### SANTA ANA RIVER TRUNK SEWER REPLACEMENT PROJECT - PHASE II

# AS-BUILT

## JANUARY 3, 2017

**SANTA ANA RIVER TRUNK SEWER REPLACEMENT - PHASE II**  
**COVER SHEET**

**SANTA ANA RIVER TRUNK SEWER**  
**REPLACEMENT - PHASE II**  
**PLAN AND PROFILE**  
**STATION 91+00 TO 100+50**

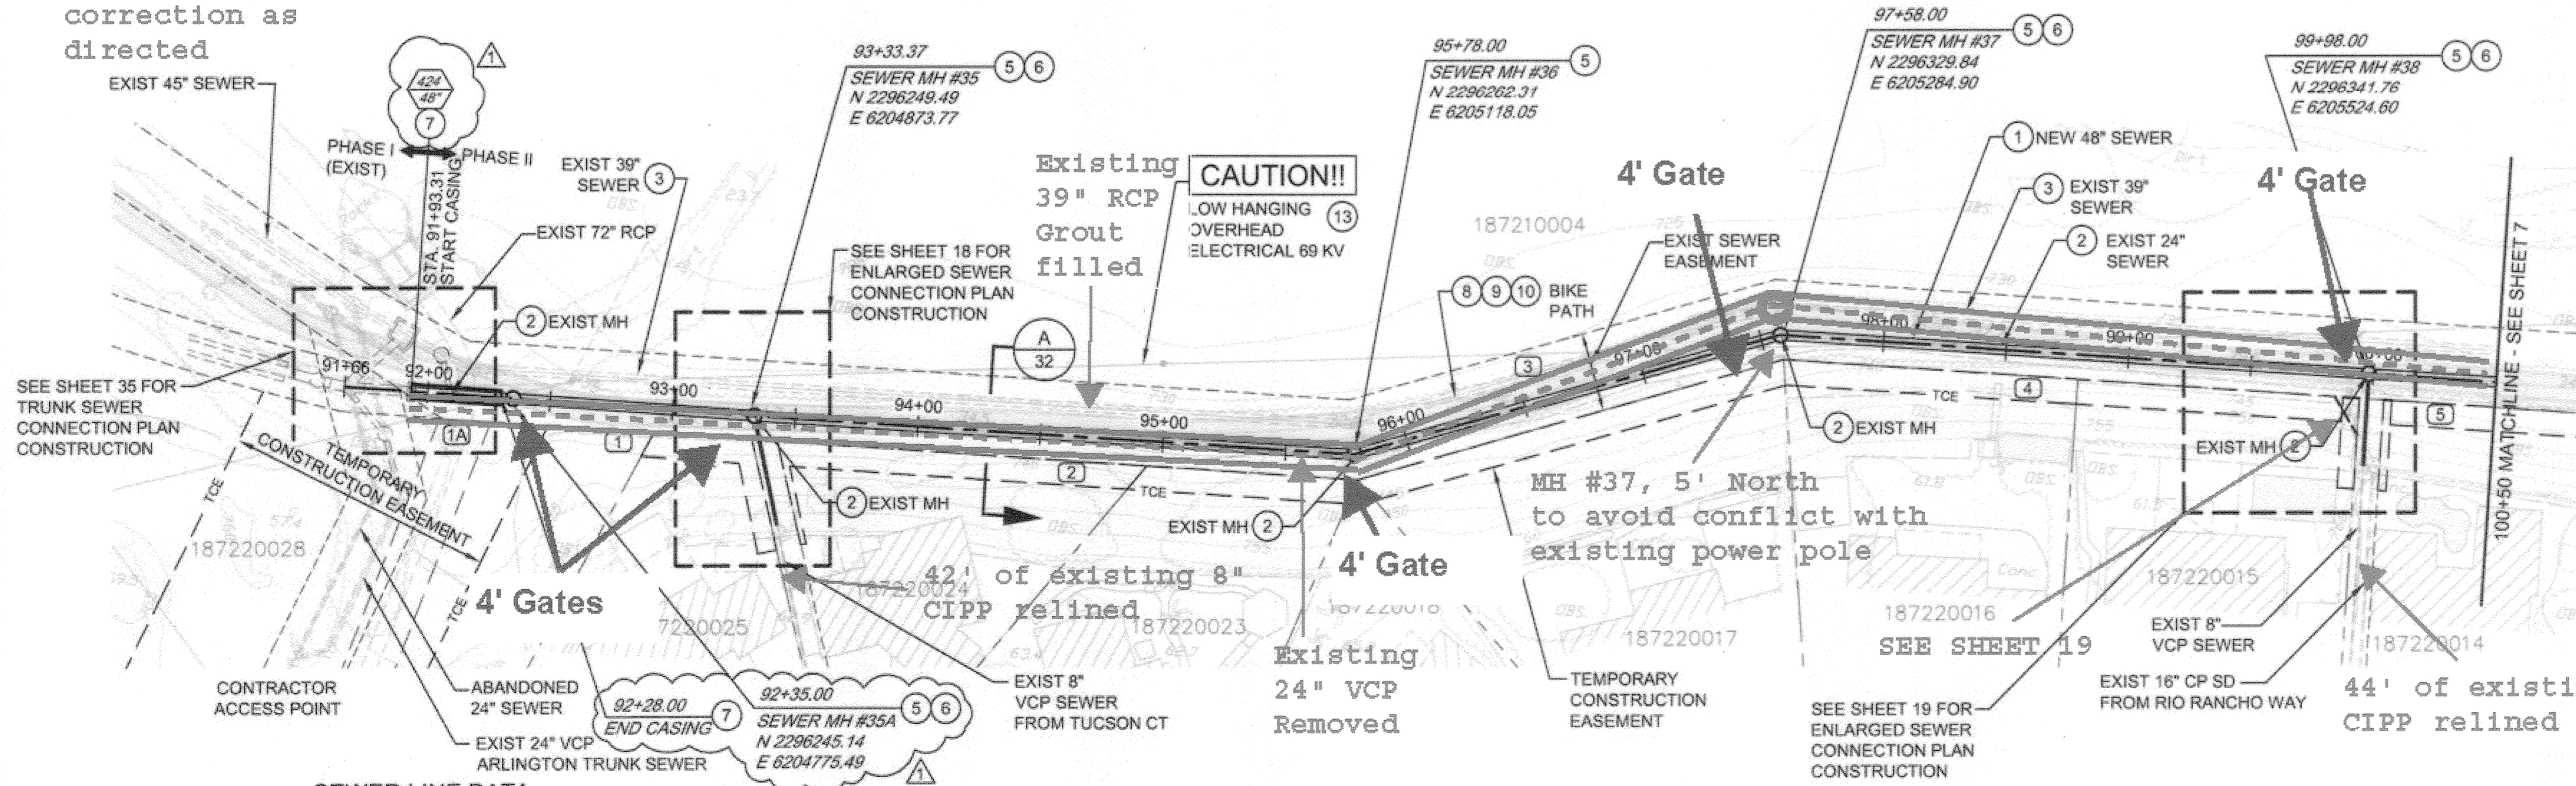
39" grout filled  
24" VCP removed  
Manholes abandoned

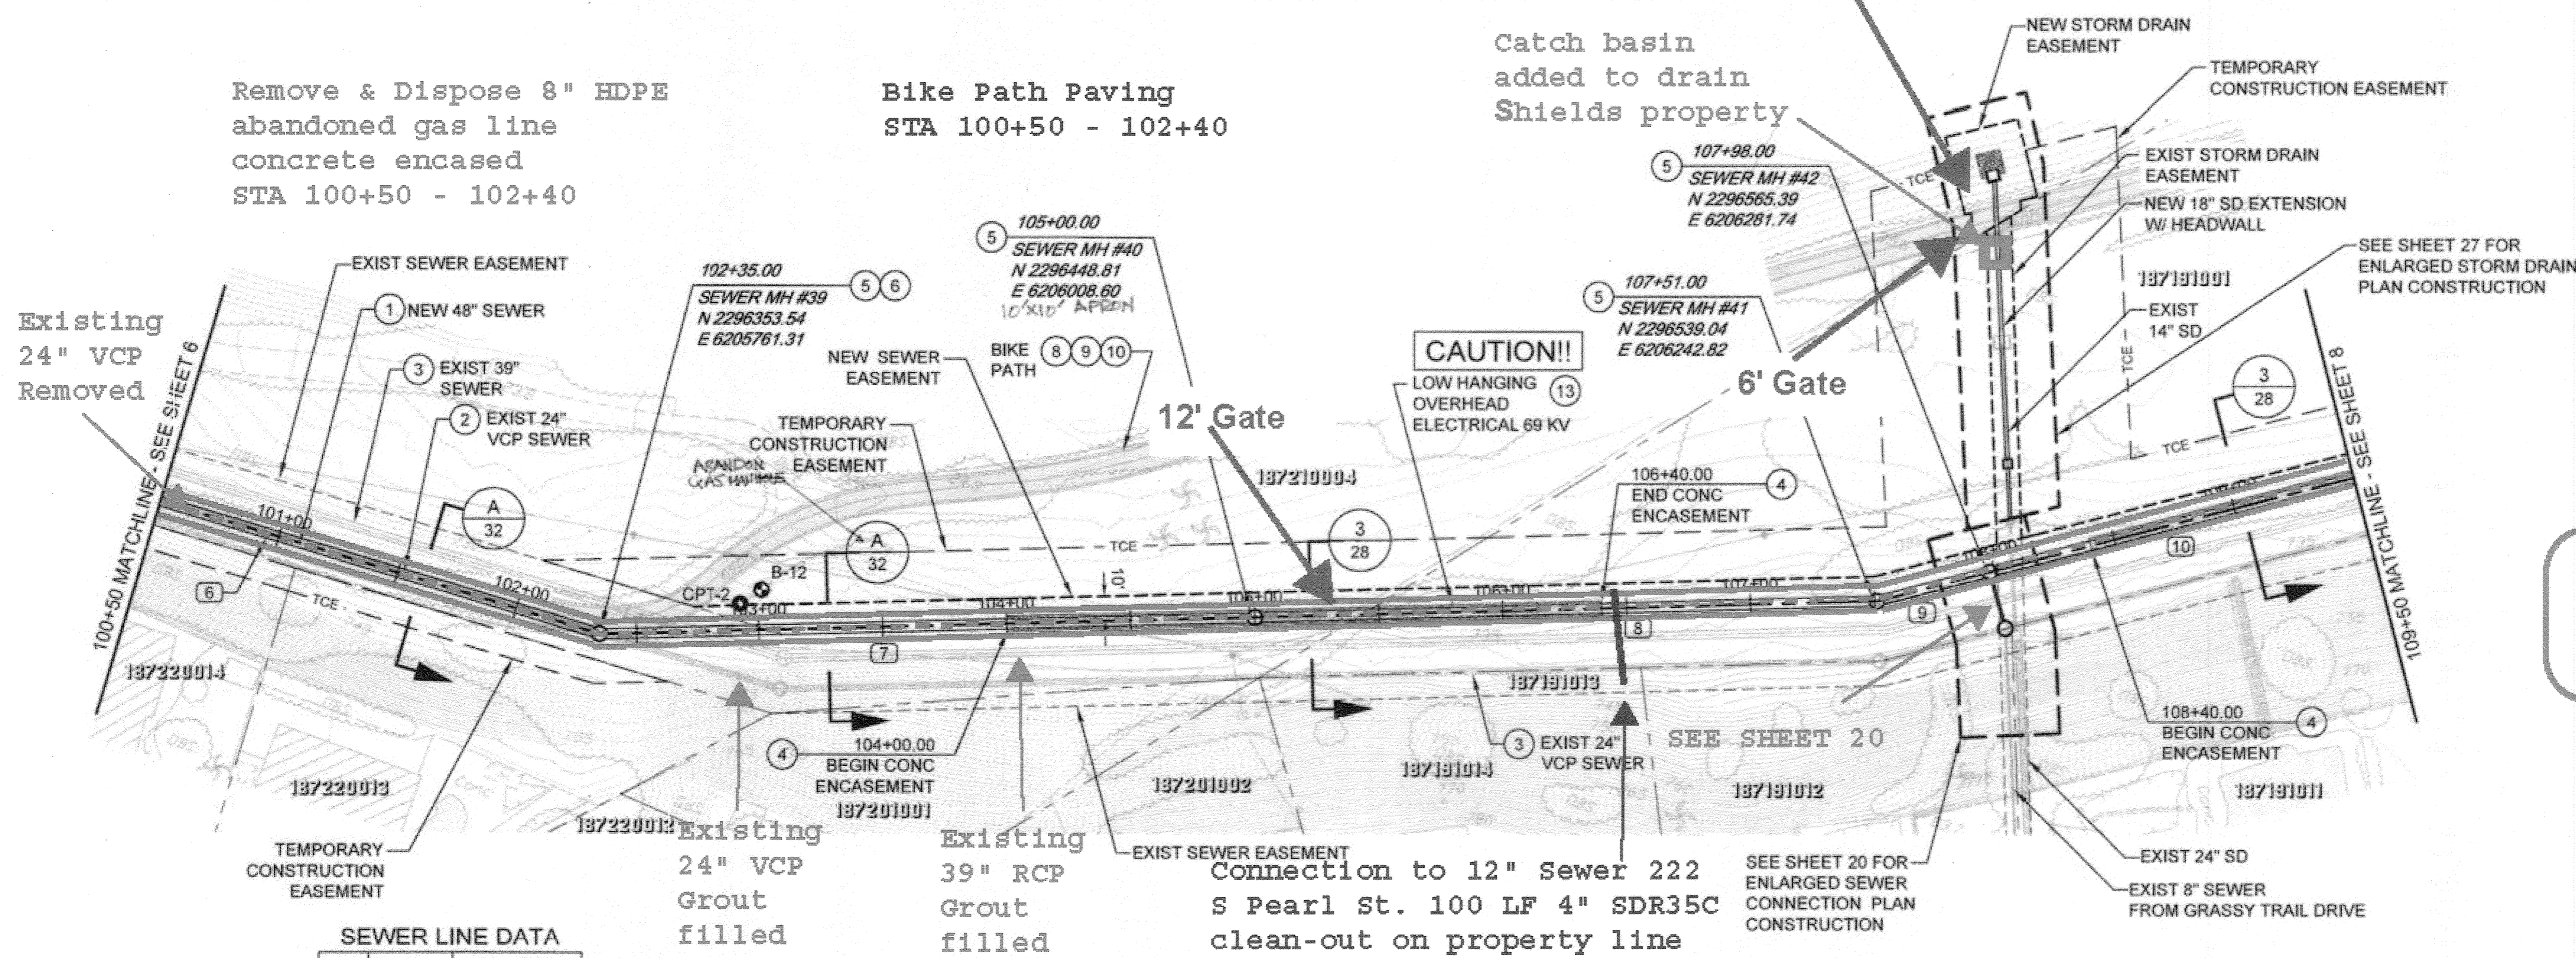
Catch basin added to drain Shields property

PLAN AND PROFILE  
STATION 127+50 TO 136+50

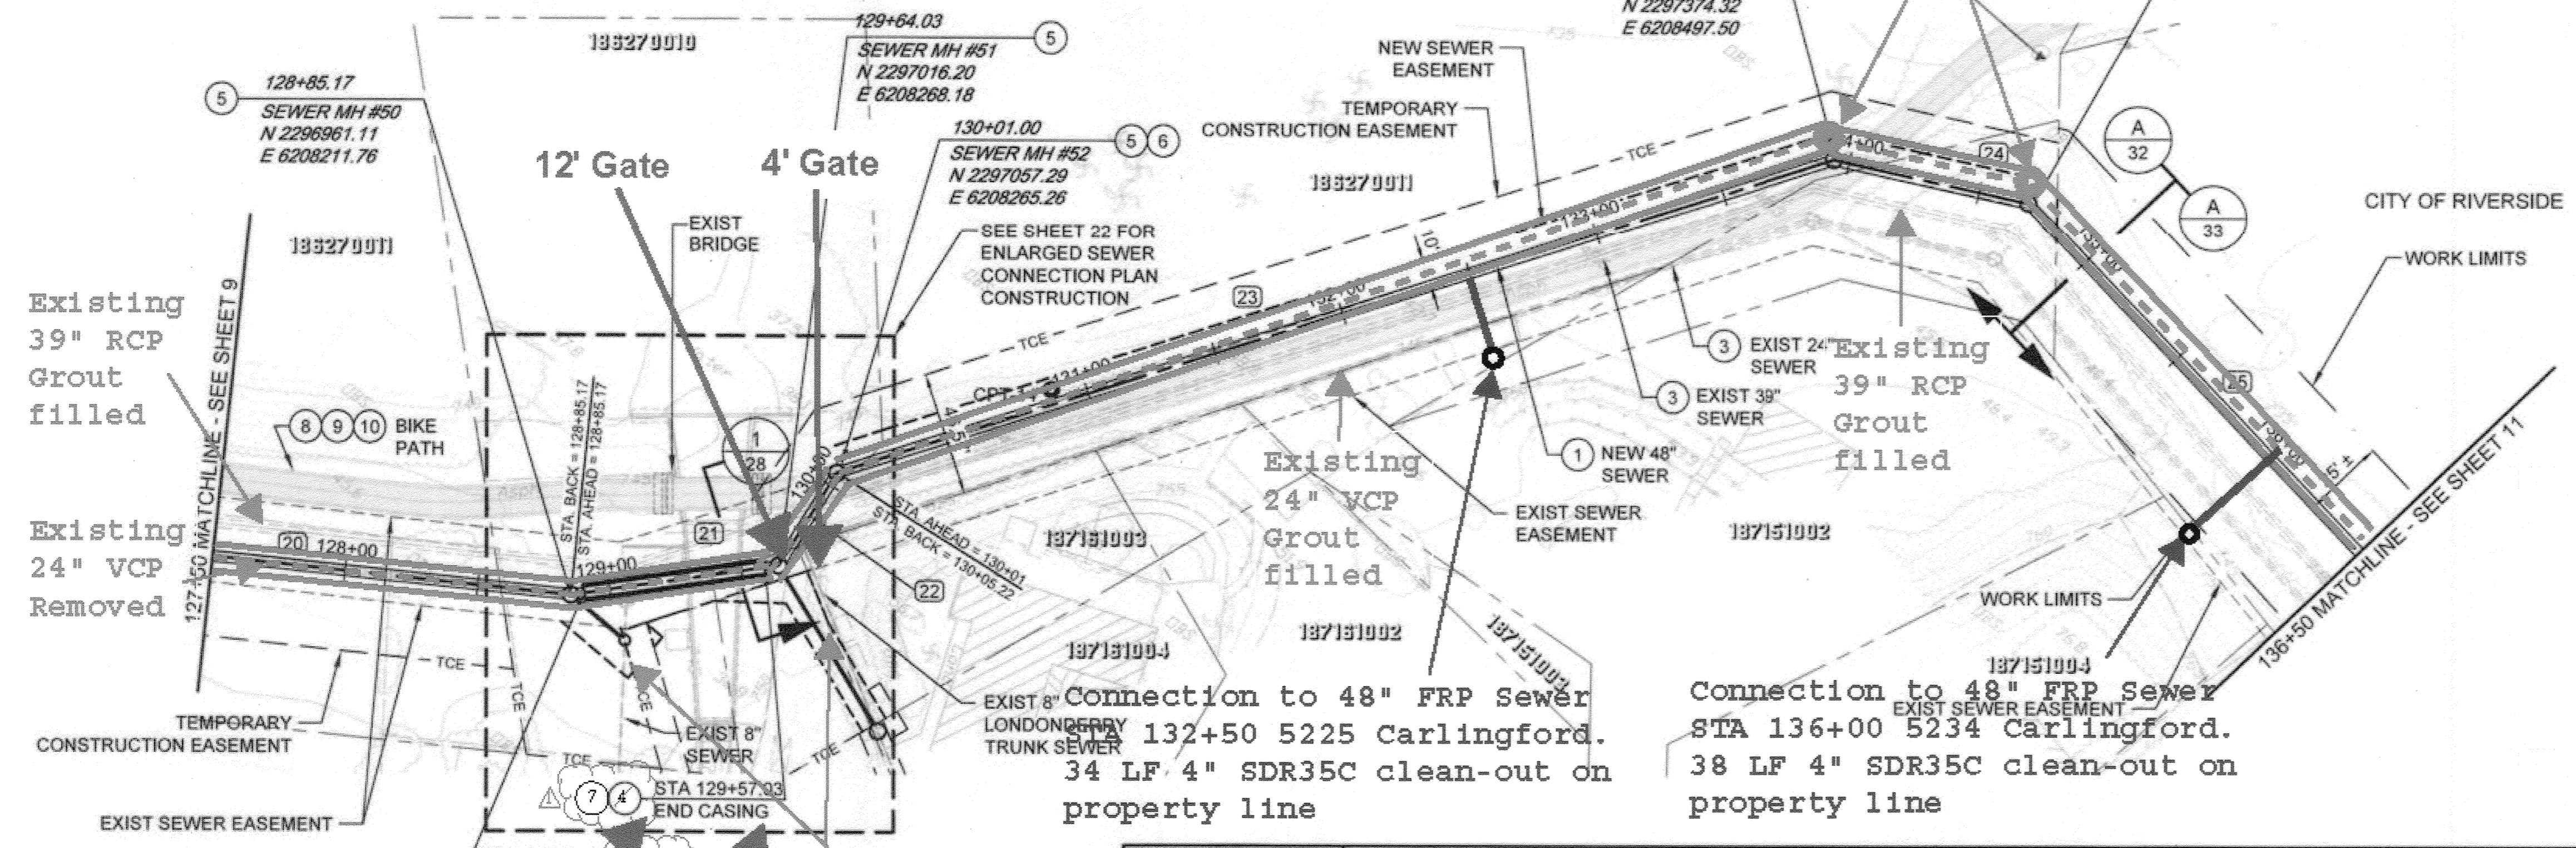
ABANDON GAS MANHOLE AS MANHOLE MH #53 & #54 5' North to avoid existing 39" conflict

**SANTA ANA RIVER TRUNK SEWER REPLACEMENT - PHASE II**  
PLAN AND PROFILE  
STATION 190+50 TO 196+25.00  
ACCT. NO.: 9799123  
S-2089  
SHEET 17 OF 35  
FILE NO. SARTS\_SHT17.DWG

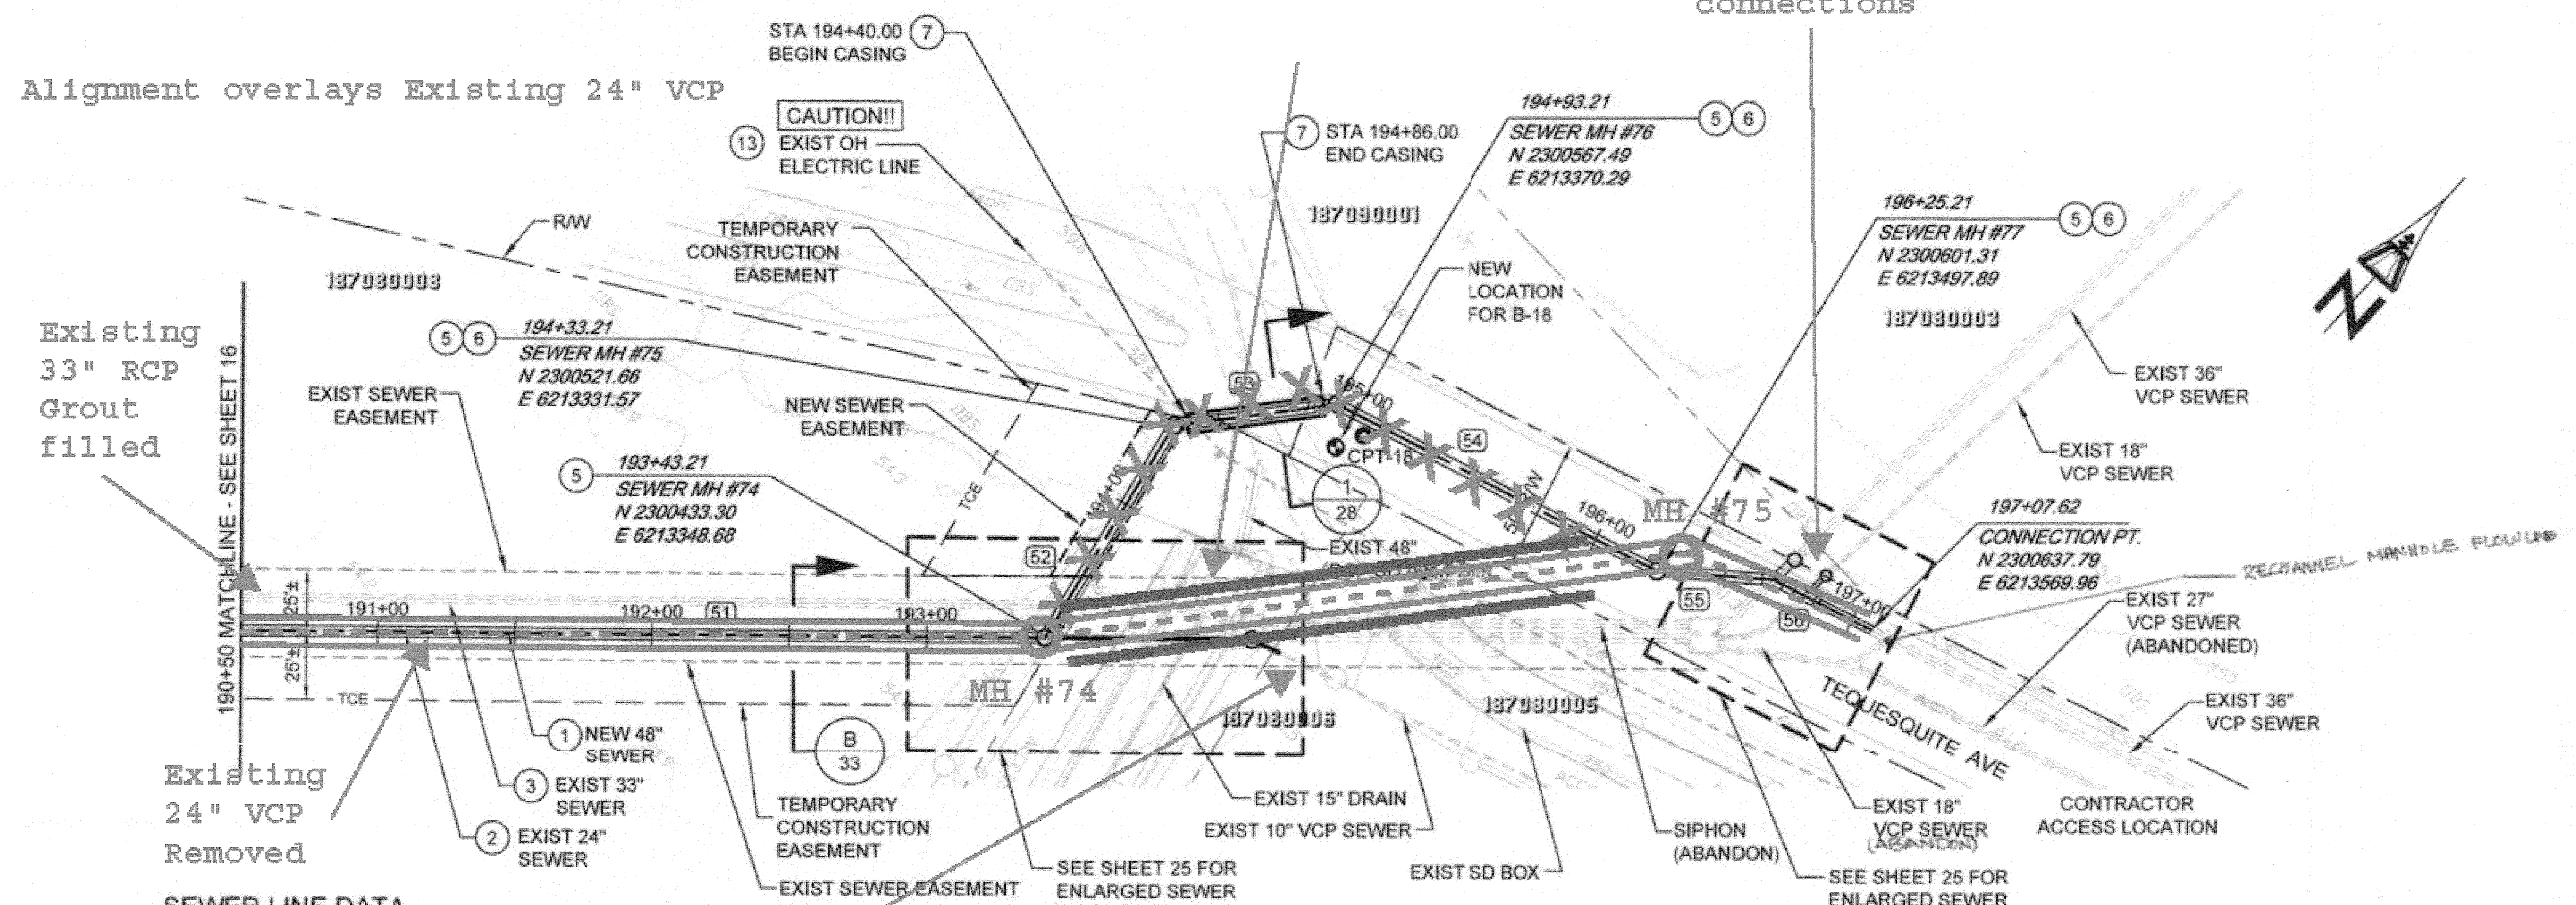
Bore encountered rip rap obstructions and was stopped at Revision 2 STA 194+84 See Sheet #25 for 36" & 18" connections

See Sheet #25 for 10" connection
